Snake River Oil and Gas, LLC
117 East Calhoun – P.O. Box 500
Magnolia, Arkansas 71753

Re: Underground Injection Control (UIC) Permit Application No. ID-2D001-A – Request for a Revised Monitoring Plan

ATTACHMENT P: Monitoring Program

Letter dated April 5, 2021, from the United State Environmental Protection Agency – Region 10 to Snake River Oil and Gas, LLC, regarding the Aquifer Exemption Request Associated with UIC Permit Application No. ID-2D001-A – Request for a Revised Monitoring Plan

Figure P-1

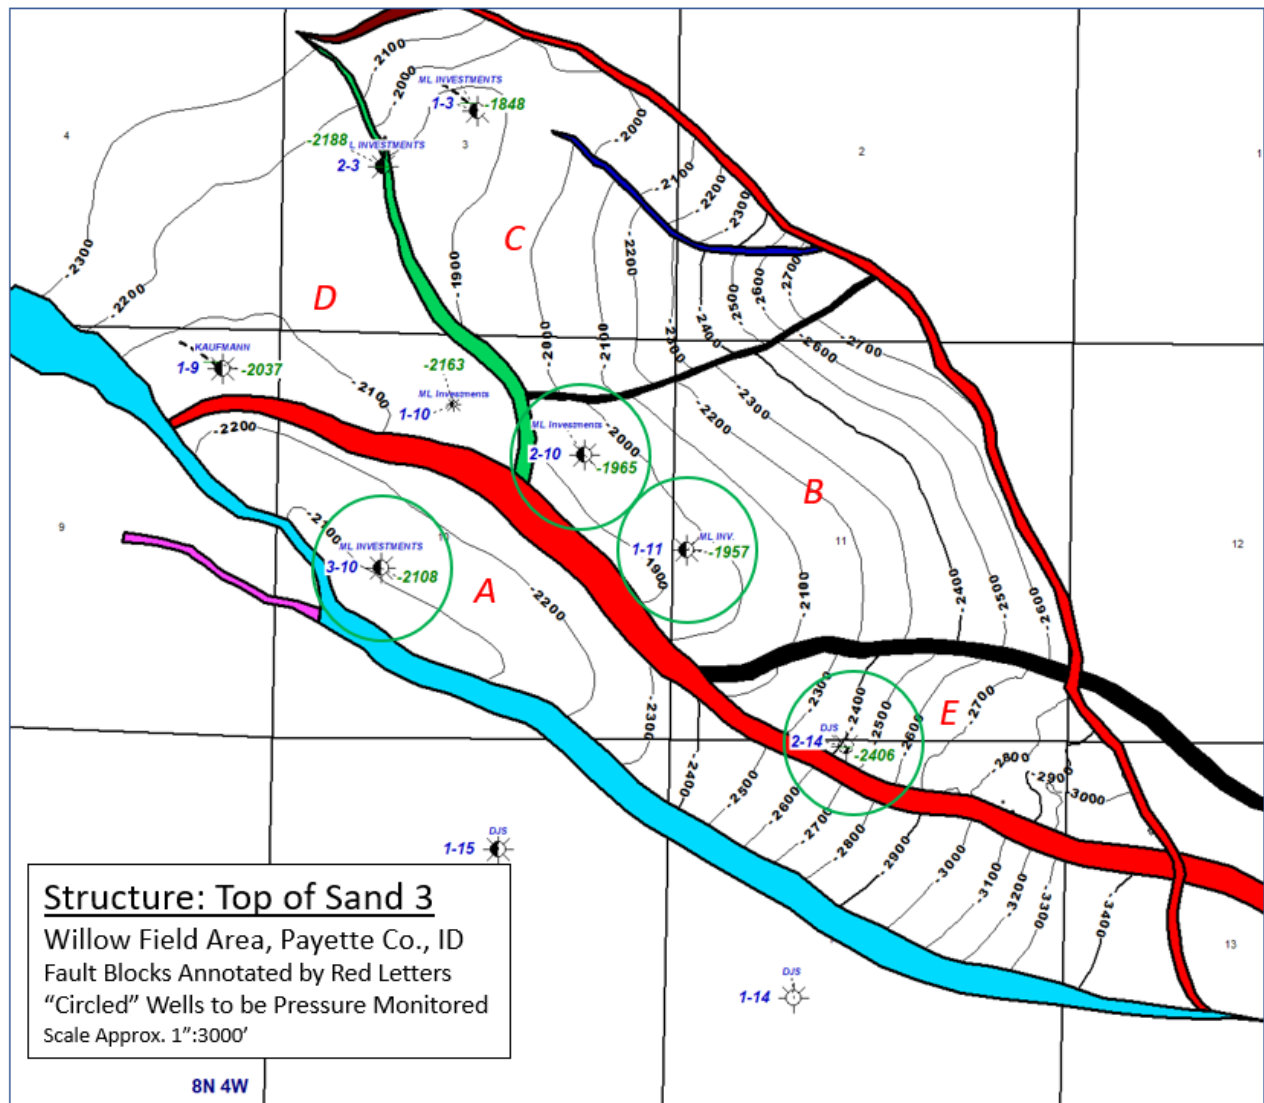
First, the current monitoring program is insufficient because it does not propose a method for evaluating the confinement of the nearest faults (i.e., the southwestern and northern faults) prior to the start of injection. While the evidence submitted to date indicates that these nearby faults are likely sealing, EPA has not received a plan for evaluating these faults prior to injection. Due to the proximity of DJS 2-14 and Block A and Block B, it is important that possible fluid communication is investigated prior to injection.

- a. To confirm that Fault Block E is currently not in hydraulic communication with Fault Block A and Fault Block B, average reservoir pressures will be measured in each fault block before beginning injection. (Refer to Figure P-1 below for a map that shows the fault blocks and wells.) Both Fault Block B and A have experienced production and consequent pressure reductions, while Fault Block E has not produced and should be at virgin reservoir pressure.

- iii. The results of these tests and all data will be analyzed and submitted to the EPA for review and approval. Separation will be shown by comparing the reservoir pressure of the DJS 2-14, in Fault Block E, to each of the reservoir pressures measured in the offset fault blocks (ML Investments 3-10 in Fault Block A, and ML Investments 2-10/ML Investments 1-11 in Fault Block B). The pressure in the DJS 2-14 should be close to a virgin pressure of a fresh water gradient (0.43 psi/ft). In addition, the pressures in each of Fault Blocks B and A should be significantly less than Fault Block E to illustrate there is no communication between the fault blocks. Assuming that Fault Block E is at virgin pressure and separation between Fault Block E and Fault Blocks A and B is apparent, SROG will request approval from the EPA to proceed with injection.

Proposed Perforations in Sands 3 and 4

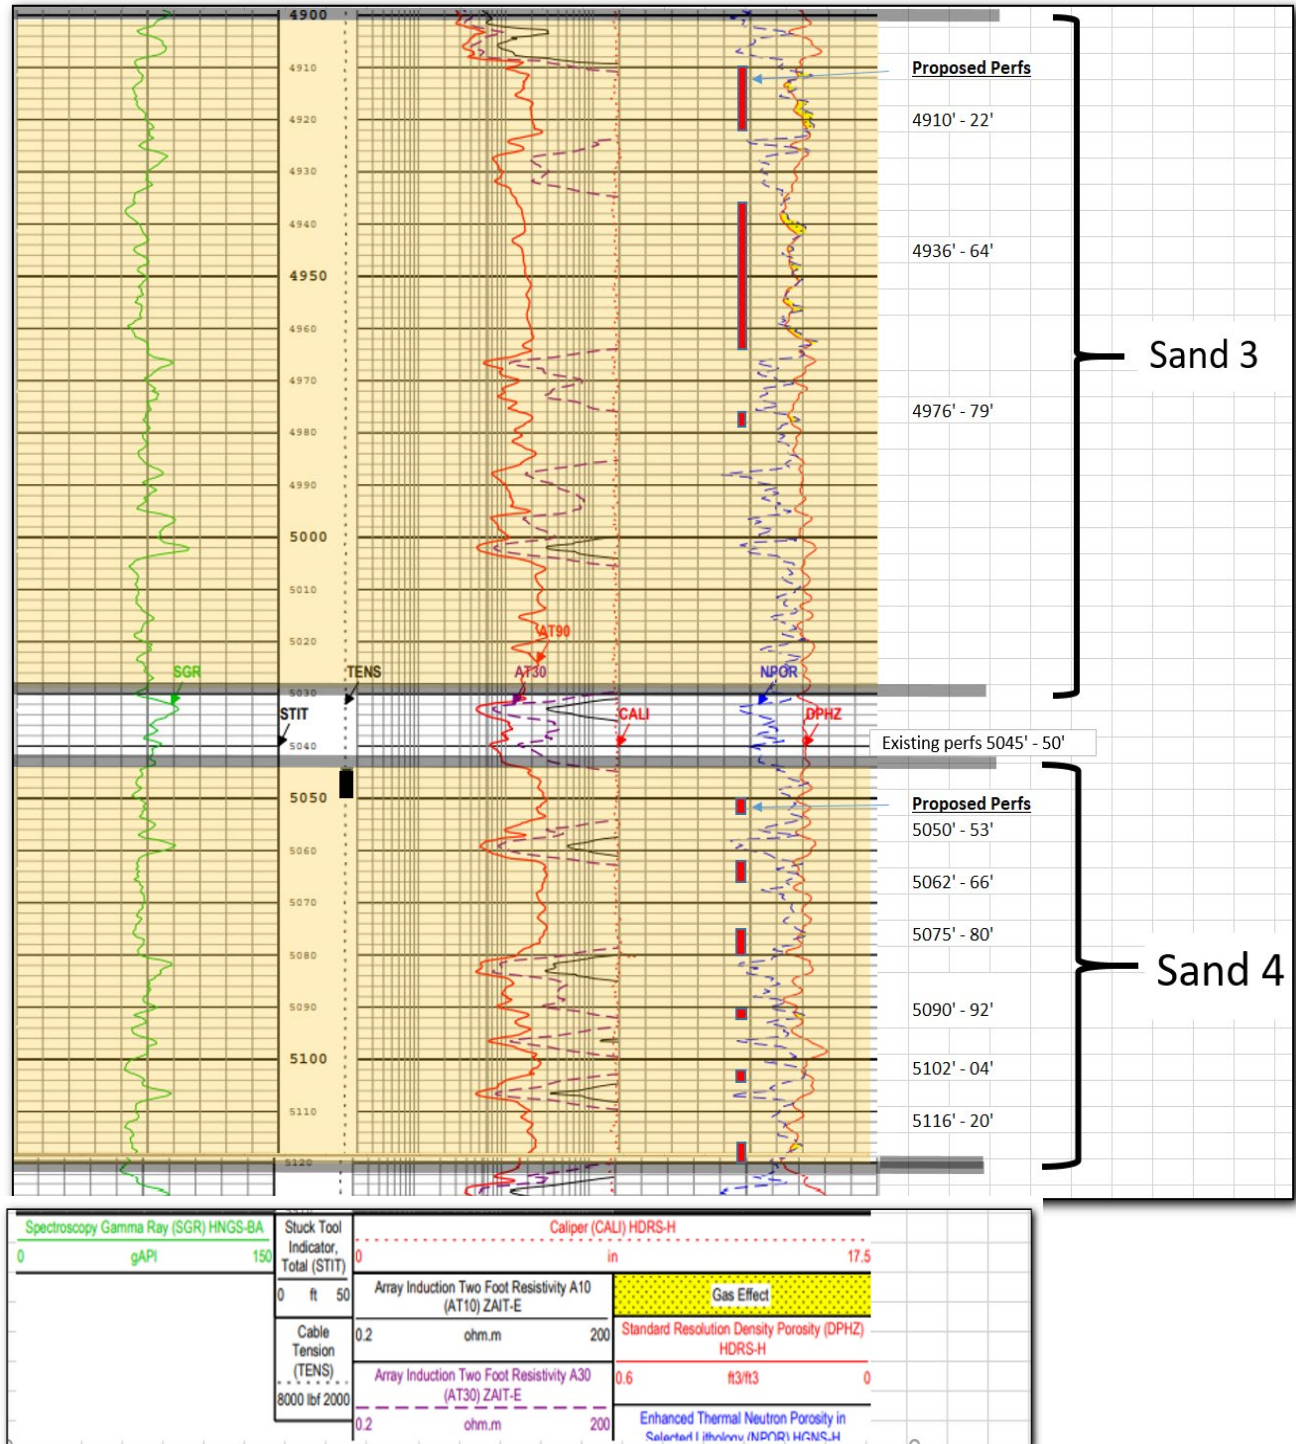
In addition, we are submitting a revised wellbore completion plan to include perforating in each of the Willow Sands to allow for injection over the entire permitted interval. This is intended to allow for hydraulic connection with the entire permeable reservoir pore space and provide for a more uniform pressure and area of injectate emplacement in the reservoir. Attachment II includes the revised Attachments L, M-5, Q-1, Q-2, and Q-3, reflecting the revised perforation intervals.

4. Add perforations:
 - a. *Sand 3*
 - i. 4,910' – 4,922'; 4,936' – 4,964'; 4,976' – 4,979'
 - b. *Sand 4*
 - i. 5,050' – 5,053'; 5,062' – 5,066'; 5,075' – 5,080'; 5,090' – 5,092'; 5,102' – 5,104'; 5,116' – 5,120'

Isopach with Circular Illustration of Area of Emplacement (7,368,000 BBL)

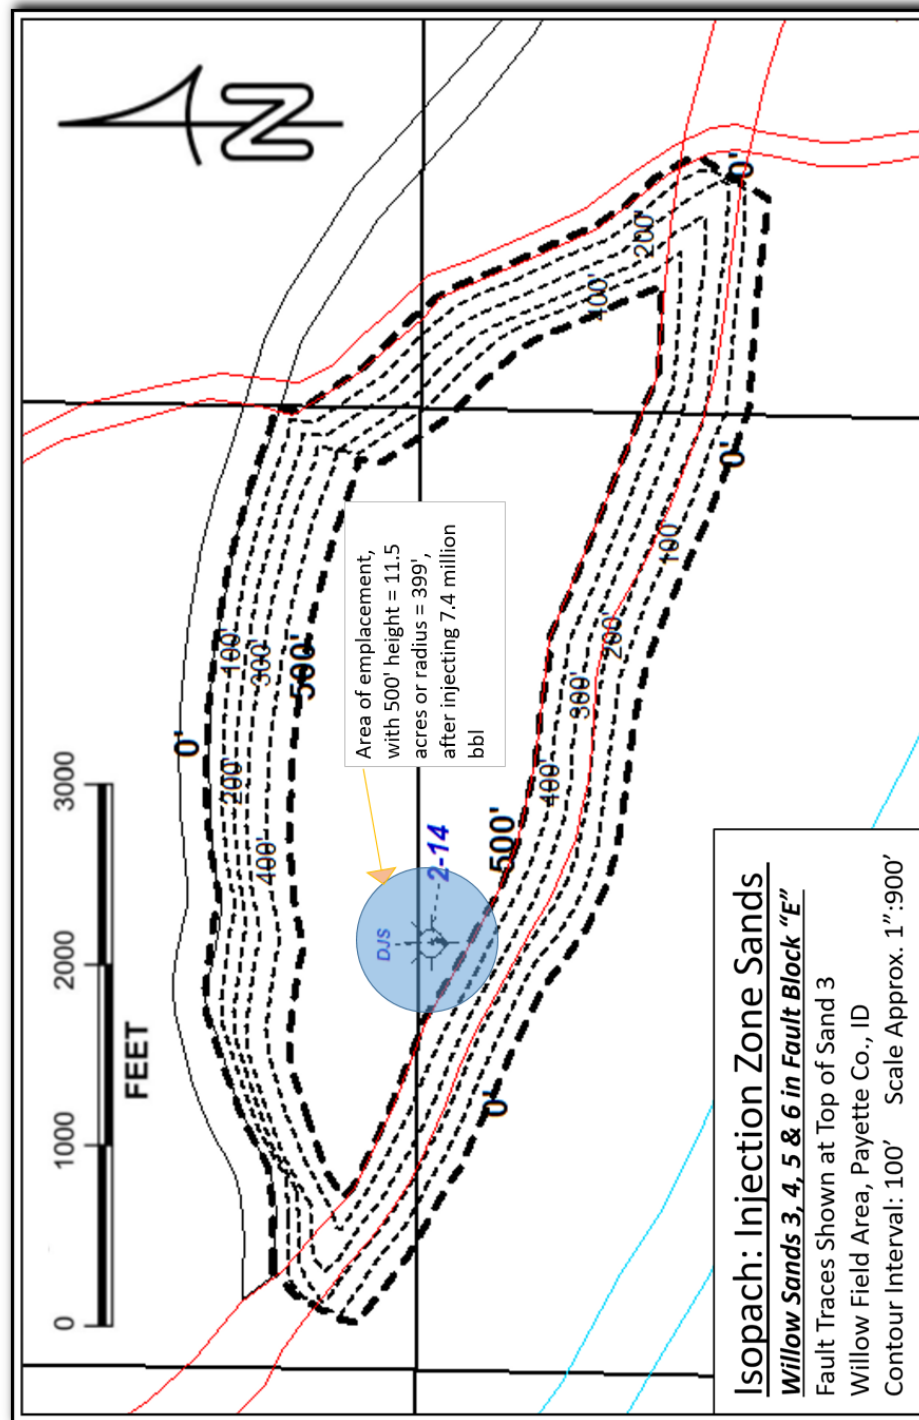
Second, the current monitoring plan does not describe how fluid movement would be monitored during the life of the well. SROG's current monitoring plan states that pressures will be monitored in offset wells to ensure they fall within "normal operating ranges," and to stop injection operations immediately once "abnormalities" are noted. This plan is insufficient because it is not sufficiently descriptive. It does not define what would be considered abnormalities outside of normal operating ranges, nor does it explain how these abnormalities would relate to fluid movement in Block E. It is also unclear what effect ongoing fluid production from Blocks A and B would have on downhole monitoring, or how the distance between these existing wells and DJS 2-14 would impact detection of movement out of Block E. A plan that includes monitoring of bottomhole pressures needs to explain how that monitoring would identify movement across the specific fault boundaries forming Block E.

The Area Of Emplacement, as defined here is the portion of the injection reservoir that is occupied by injectate, when viewing the reservoir from a top-down vertical view. As produced water is injected into the pore space in the reservoir, mobile reservoir fluids are assumed to be displaced by the injectate. For this illustration, it is assumed that the displacement is uniform and 100% efficient, providing a simple solution for determination based on the final geometrical shape of the emplacement. In this case, since the gas saturation of 20% is assumed to be residual and immobile, the gas saturation serves to reduce the available pore space available for emplacement. The area of emplacement is calculated and shown below based on a simple volumetric method, with no consideration of compressibilities, and assuming a homogenous reservoir of uniform porosity and permeability. Note that the effect of ignoring compressibilities causes the area calculated to be slightly larger than actual. Each of the gas, water and matrix compressibilities would create a smaller area of emplacement than is shown here. The assumption made is that the AOE will conform to a cylinder with the axis about the wellbore, appearing as a circle in map view. The vertical height of the emplacement is simplified by utilizing the isopach thickness seen in the DJS 2-14 well. For this illustration, the circle is centered over the well. Note that southwestern portion of the circle impinges on the isopach wedge below 500' thickness. No effort was made to account for this, since the main point of this calculation and display is to illustrate the relative areas of the emplacement versus the area of the isopach. As shown below the area of emplacement is approximately 11.5 acres versus the total reservoir area of 269 acres. Note that this AOE is for a total injected volume of approximately 7.36 MMBW.
